Re: S/D 97-18 - FINAL PLAT OF PARK MEADOW ESTATES 3RD ADDITION

STAFF REPORT

CASE NUMBER: S/D 97-18 - PARK MEADOW ESTATES 3RD ADDITION

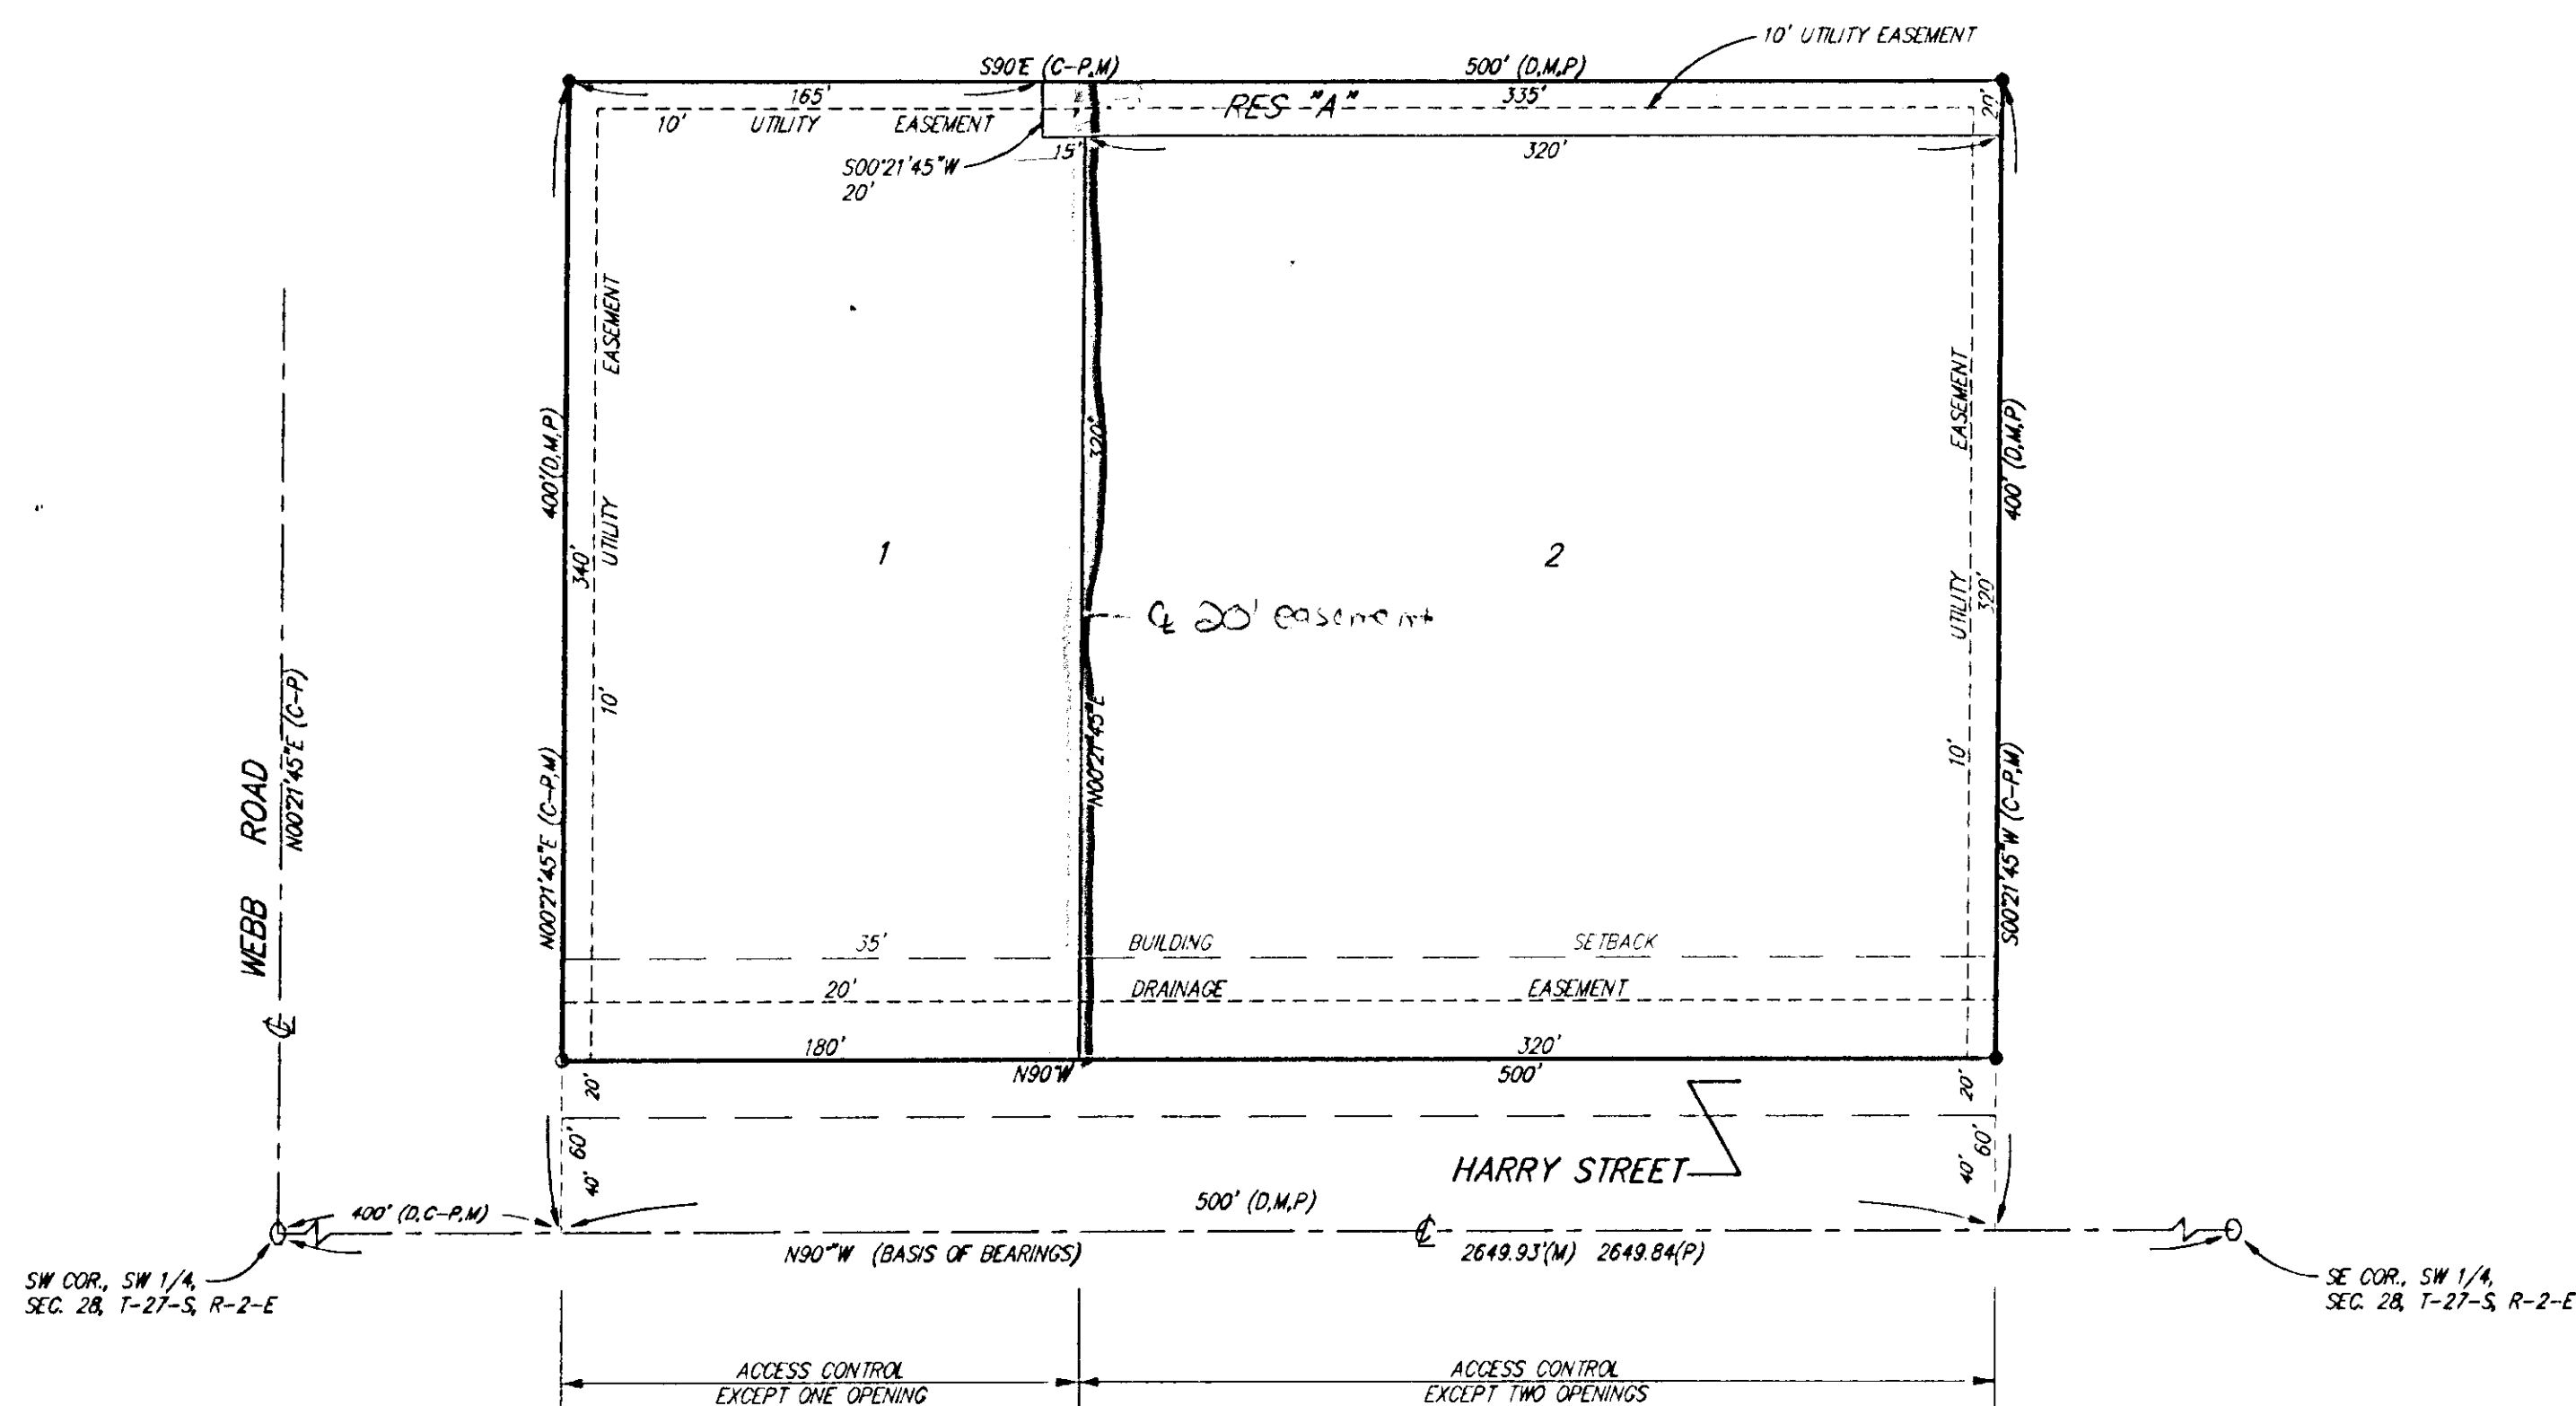
- ✓ D. Traffic Engineering indicates proposed access controls are satisfactory. Engineering is asking for a left-turn lane to be provided to the eastern most access point on Harry. Engineering also indicated a willingness to meet with the applicant to discuss the left-turn lane.

- ✓ E. A sidewalk should be provided along Harry.
- ✓ F. The applicant shall guarantee the construction of any drainage improvements required by the platting of this property including storm sewers. Engineering indicates storm sewers would need to be extended to match the left-turn lane along Harry.

- ✓ H. City Engineering needs to comment on the status of the applicant's drainage plan. City Engineering needs a drainage guarantee.

- M. The representatives from the utility companies should be prepared to comment on the need for utility easements to be platted on this property. Attached are KG&E's request for additional utilities.

NOTE: This site is approved by the MAPC, subject to platting, for "LC", Limited Commercial zoning, (SCZ-0727). That zone case included a requirement for a 20-foot wide landscape buffer along the northern property line when adjacent to residential zoning.
